# A428 Black Cat to Caxton Gibbet improvements

9.55 Applicant's response to Cambridgeshire County Council's  
comments on archaeological mitigation areas

**9.55 Applicant's response to Cambridgeshire County Council's  
comments on archaeological mitigation areas**

<b>Regulation Reference:</b>	Rule 8(1)(k)
<b>Planning Inspectorate Scheme Reference</b>	TR010044
<b>Application Document Reference</b>	TR010044/EXAM/9.55
<b>Author</b>	A428 Black Cat to Caxton Gibbet Improvements Project Team, National Highways

Site Number and Field Number	CCC Position	Applicant Position
	 <p data-bbox="546 1459 1403 1493">Plate 35 Proposed CCC Area Site 19 36, 38 &amp; 39 (4th November 2020)</p>	 <p data-bbox="1952 1255 2332 1289">Plate 36 AMS Area Sites 36-39</p>

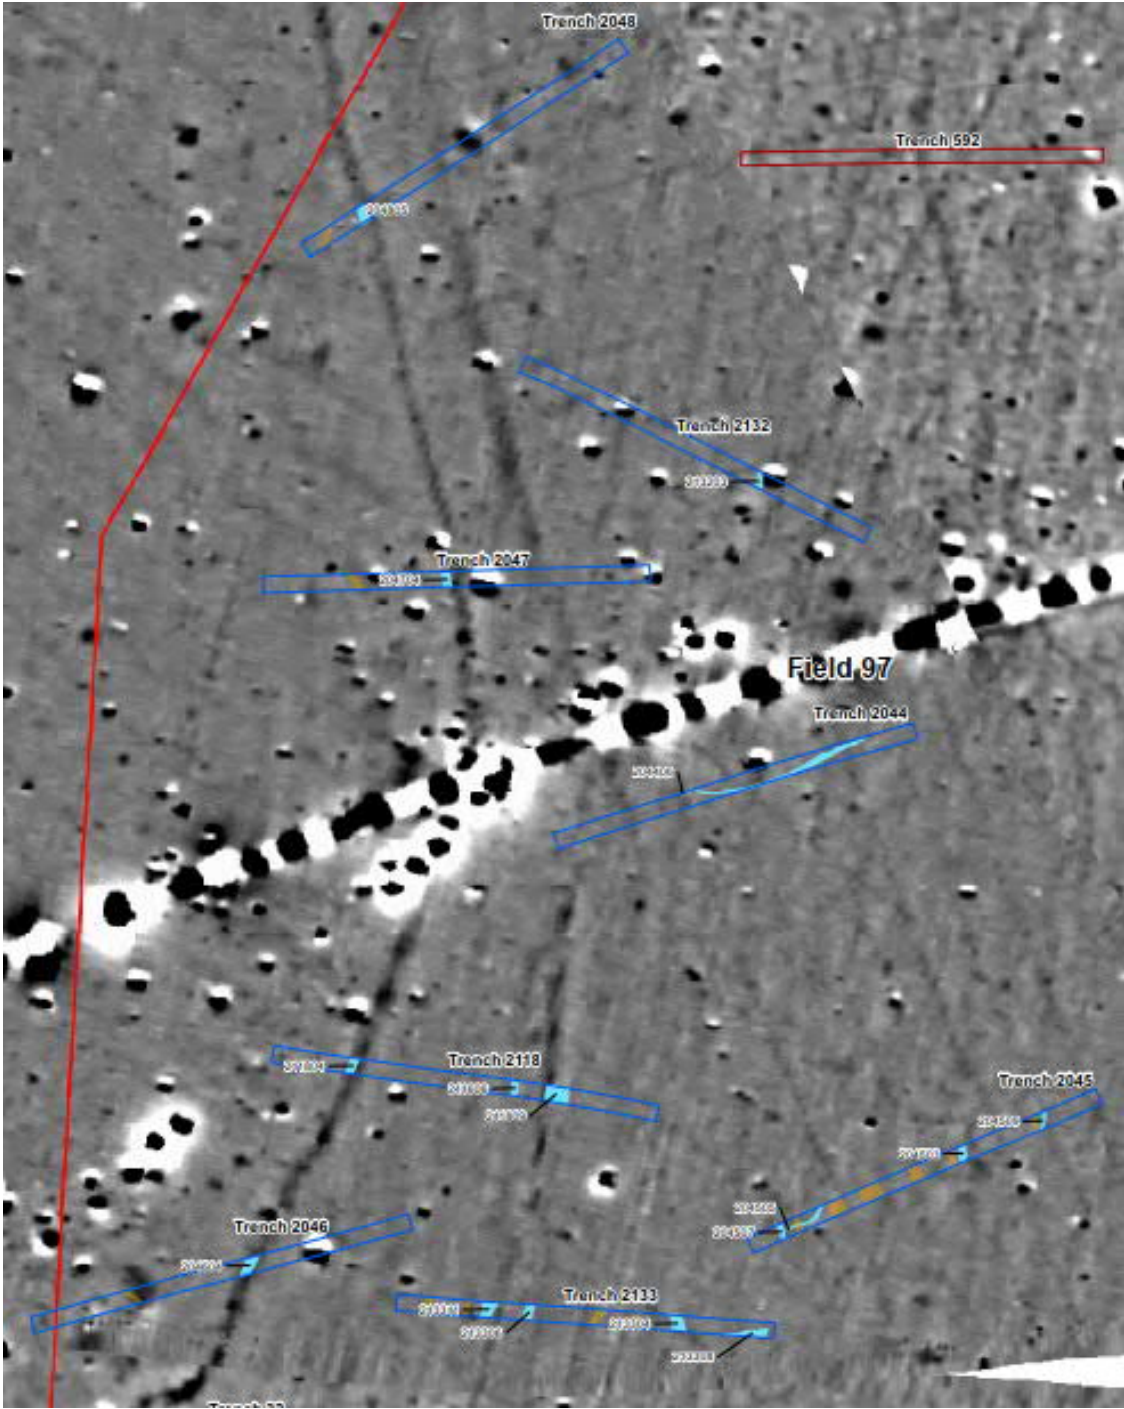
Site Number and Field Number	CCC Position	Applicant Position
Site 36, 37 & 39, Field 97	<p><u>Site 36</u> Not approved.</p> <p>When viewed against the geophysical survey results, the maplet in Appendix D for this site shows an excavation box that seeks to avoid archaeological features to the north and northeast, including the parish or hundred boundary. This requires modification to enable it to be fit for the purpose of the archaeological examination of known Iron Age remains, partly truncated by a pond lying just outside the DCO boundary, around which further archaeological evidence can be anticipated owing to the orientation of the known archaeological evidence that heads towards Site 34 in Field 95. The excavation box should, therefore, also extend south to the north boundary of the Cambridge Road.</p> <p><u>Site 37 Field 97</u> Not approved.</p> <p>The parish boundary adjacent to and the west side of the DCO boundary and within the borrow pit area has been avoided by the proposed excavation box.</p> <p><u>Site 39 Field 97</u> Not approved.</p> <p>This site areas form a continuum with the Iron Age settlements in this area around Caxton Gibbet. The site area selected for excavation is tight to the geophysical anomalies of enclosed settlement form that are not well understood and prevents a wider view of activities that can be expected outside the settlement core particularly relating to unenclosed occupation activity. The maplet for this site in Appendix D should be redrawn to widen the area to the northeast and south west.</p>	<p>For all sites within Field 97 there is no justification to extend the areas. The mitigation sites have been placed where there is archaeological evidence. The mitigation areas within Field 97 have been based on the results of the various phases of evaluation, including desk-based research, analysis of aerial photographs and LiDAR, geophysical survey, and evaluation excavation. There were 57 trenches excavated across this field. The evaluation evidence demonstrates that the geophysical survey was accurate, with the features identified on the geophysical survey and on aerial photographs located during the evaluation trenching. Furthermore, the areas between the enclosures are largely blank of features. There are seven trenches outside of the mitigation areas which contained archaeological features. All of these features were post-medieval in date, with one undated ditch located. The parish boundary was identified in three trenches which, where excavated, contained a modern land drain at its base.</p> <p>The parish boundary was sampled in the evaluation. The evaluation report (see Appendix 6-8, <b>[APP-176]</b>) notes:</p> <p>“The boundary between the parishes of Papworth Everard and Yelling was excavated in T2046 and T2048 and also recorded in T2047 and T2118 (Image 10). Though the parish boundary may have been marked by an earlier feature, this boundary survived as a ditch c1m wide and up to 0.65m deep, with a large ceramic drain at the base. Which [sic] had presumably removed any earlier iterations of the boundary. Pottery dating between 1790 and 1830 was recovered during Phase 1, and the boundary existed into the 20th century, recorded on OS mapping.”</p> <p>There is no evidence of an earlier boundary. While there are various iterations of the boundary shown on the geophysical survey, there is no surviving sub-surface evidence. A section through the parish boundary can be seen on Plate 40.</p>
